RSB – 05222024-03K

RECALL SERVICE BULLETIN

TITLE: Relay Valve on Tandem Rear Axles

VEHICLES: Vehicles Part of KME Recall 24V-363/TC ID: 2024-288

Figure 3.1 Relay Valve Location

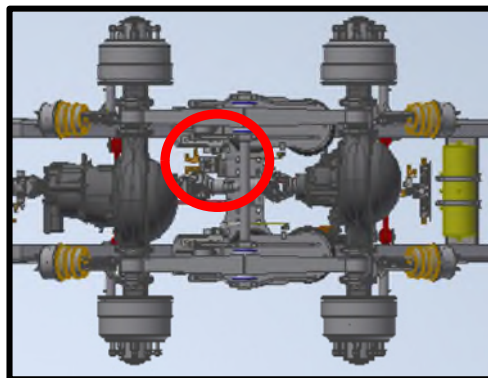
1. Ensure the vehicle park brakes are set and the wheels are chocked.
2. Locate the relay valve behind the rear tandem axle on the frame rail.

NOTE: The relay valve is mounted to the crossmember near the rear drive axle under the truck. (See Figure 3.1)

Figure 3.3 Air System Schematic with Relay Circled

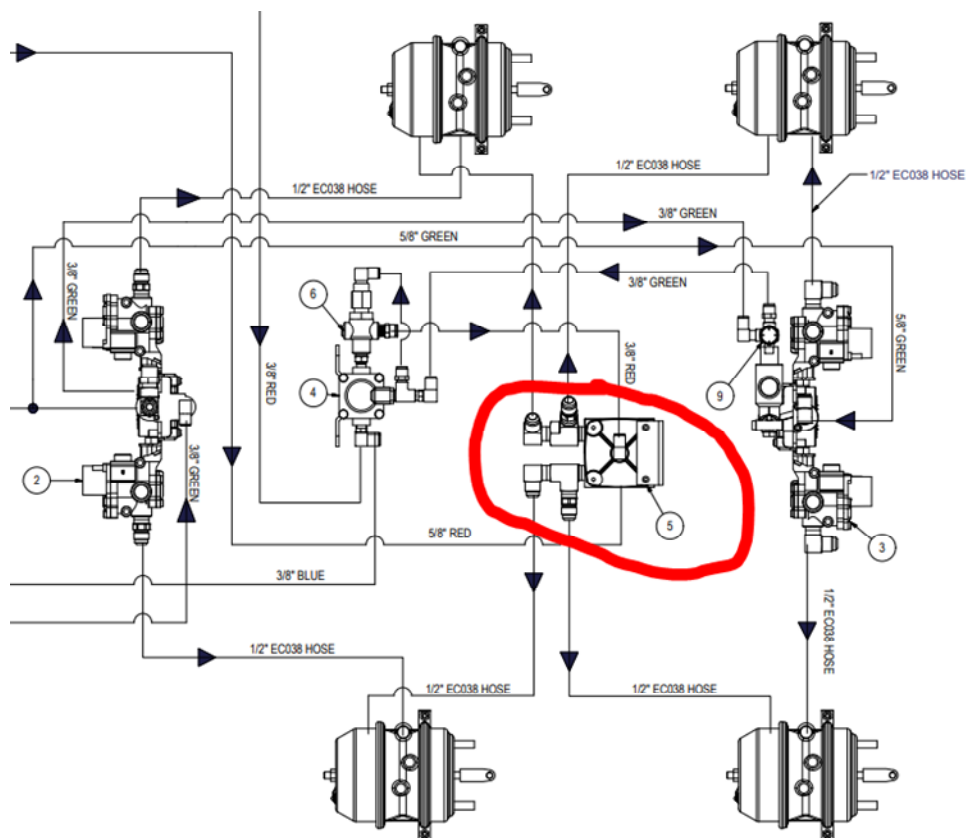
ISSUE: Rear park brakes may fail to apply.

CORRECTIVE ACTION: Inspect for correct relay valve. If the valve is incorrect, replace with correct relay valve. See KME PARTS REQUIRED below and Work Instructions.

1 REV Number 076413V (103009) – Valve, R12 Relay
